Access Compliance Report

Public Rights-of-Way

Intersection ID: 30498	Main Street: BEDDINGFIELD_DR	Cross Street: ORCHARD GRASS_CT	Location: NE
ADA ID: 11B88812C271	Ramp Type: PerpDiag	Initial Pass/Fail: Fail	Overall Compliance: No
		Severity Score: 10

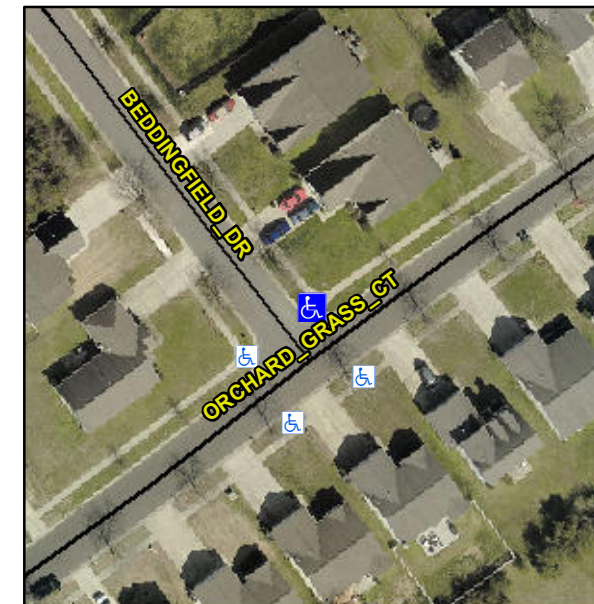
R304.5.1, R304.5.3

Compliance	Description	Data	Compliance	Description	Data
N/A	Ramp Length (in)	84.0	Yes	Ramp Slope (%)	7.7
No	Ramp Width (in)	38.0	No	Ramp XSlope (%)	2.5
N/A	Flare Type LT	N/A	N/A	Flare Type RT	N/A
N/A	Flare Slope LT (%)	N/A	N/A	Flare Slope RT (%)	N/A
N/A	Flare Traversable LT?	N/A	N/A	Flare Traversable RT?	N/A
N/A	Landing Length (in)	N/A	N/A	DWS Provided?	N/A
N/A	Landing Width (in)	N/A	N/A	DWS Contrast?	N/A
N/A	Landing Slope (%)	N/A	N/A	DWS Length (in)	N/A
N/A	Landing X Slope (%)	N/A	N/A	DWS Full Width?	N/A
N/A	Landing Curb? (Y/N)	N/A	N/A	DWS Offset (in)	N/A
N/A	Shared Landing?	N/A			
N/A	Gutter Ponding?	N/A	N/A	Gutter Slope (%)	N/A
N/A	Gutter Lip Ht (in)	N/A	N/A	Gutter X Slope (%)	N/A
N/A	Painted X Walk1?	No	N/A	Painted X Walk2?	No
	X Walk 1 Direction	To SW		X Walk 2 Direction	To SE
N/A	X Walk 1 Width (in)	N/A	N/A	X Walk 2 Width (in)	N/A
	X Walk 1 Slope (%)	1.4		X Walk 2 Slope (%)	2.4
	X Walk 1 X Slope (%)	0.8		X Walk 2 X Slope (%)	0.3

Remove & Replace Curb Ramp With Two New Directional Ramps or Equivalent.
